Addendum No. 4

Project: Guilford County Law Enforcement Center Renovation
Rebid Event # 629

Addendum Date: August 2, 2018

ELEVATOR SMOKE CURTAIN DETAILS

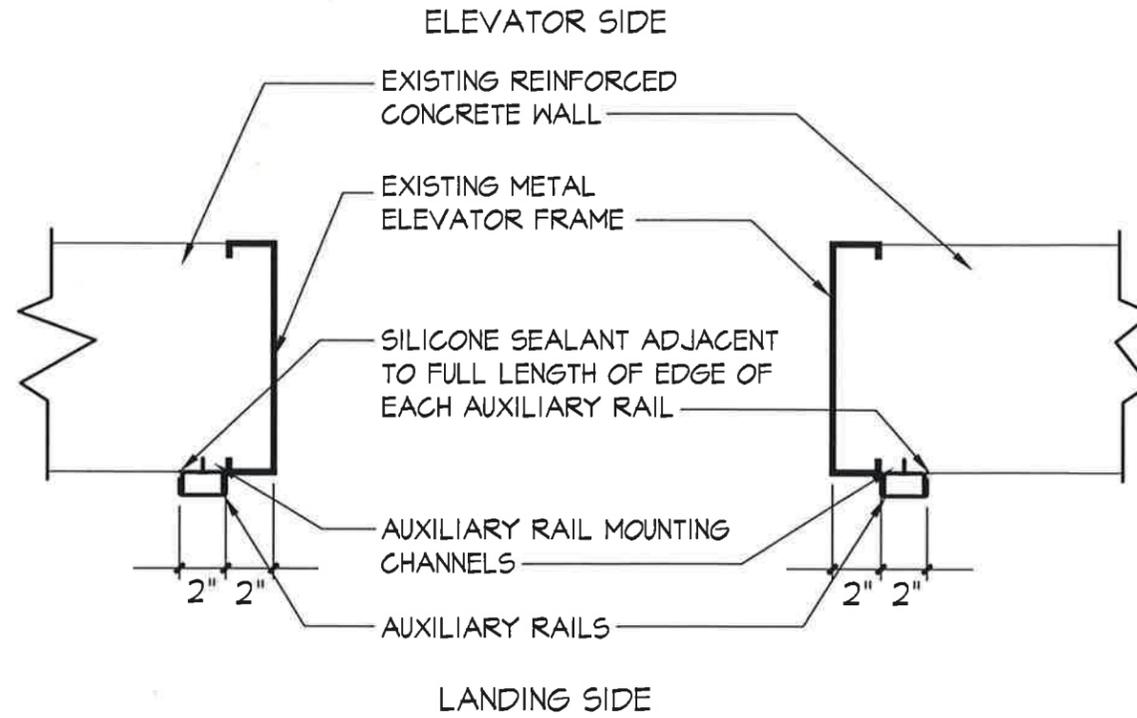
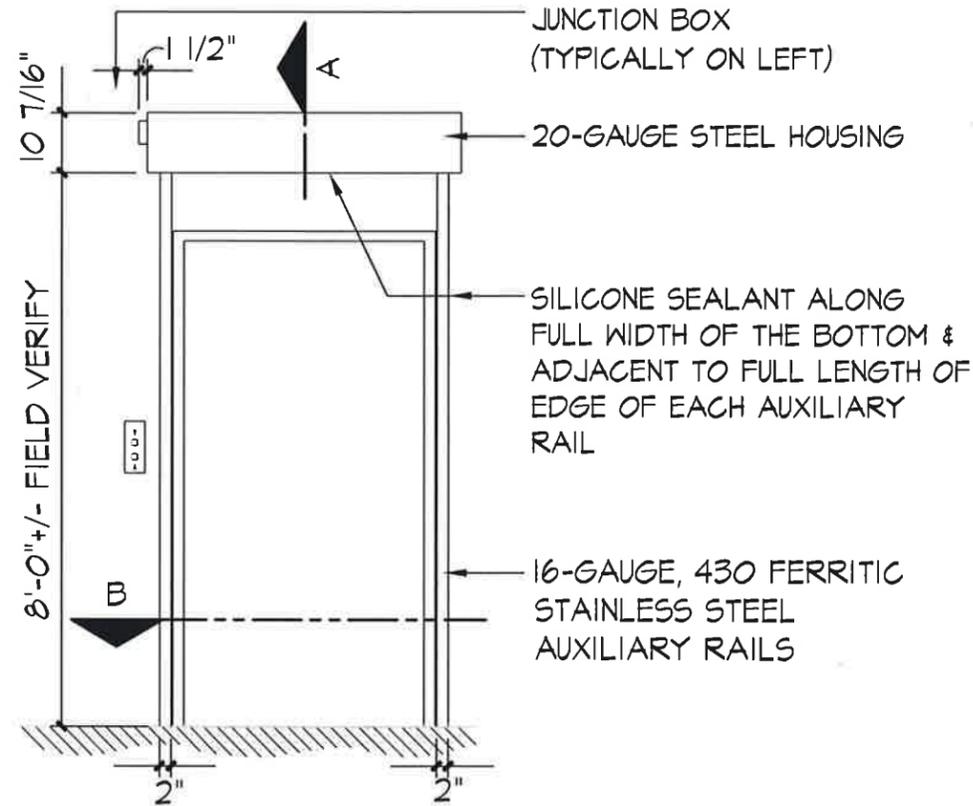
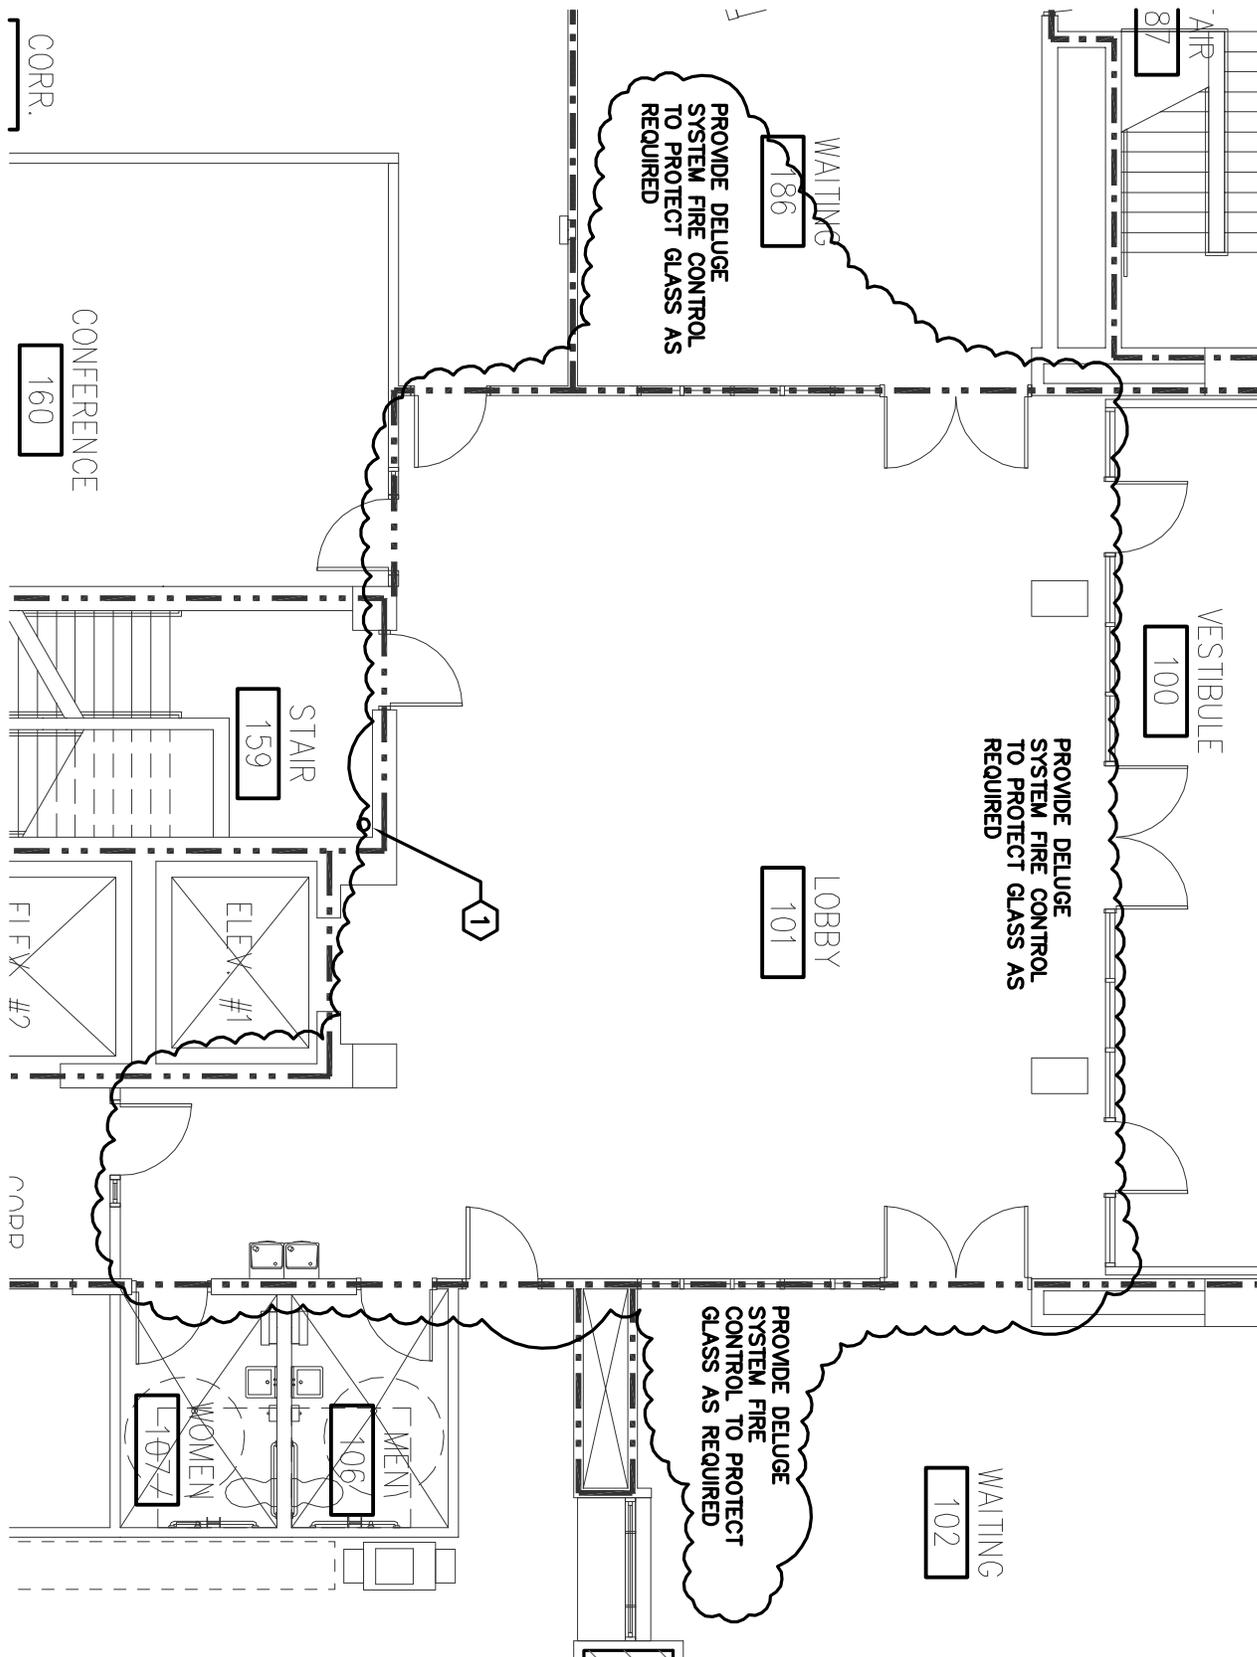
17. A10.4 Detail 10429 Elevator Shaft Single Door: Delete detail. Replace with detail ADD 4-1. (attached)
18. A11.1 Door and Frame Schedule: Delete the following elevator doors/hardware and provide smoke curtains at each opening per spec section 08 34 83: Doors 202A, 202B, 306A, 307A, 402A, 407A, 502A, 507A, 606A, 607A, 702A, 707A, 802A and 807A.
